Service Bulletin

Bulletin No.: 19-NA-277

Subject: Poor Fuel Transfer and/or Rear Fuel Tank Collapsed

5398956

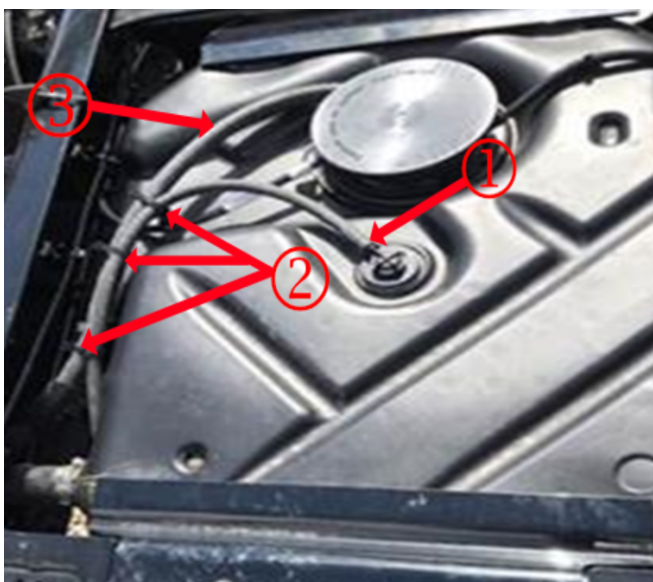
5. Cut one piece of KENT Lawson fuel line hose P/N 6637 or equivalent, 74 cm (29 in) and install one end to the vent (1) then route using 3 zip ties (2) down the fuel feed line (3), as shown in the picture above.
6. Reinstall the new fuel tank. Refer to *Fuel Tank Replacement* in SI.
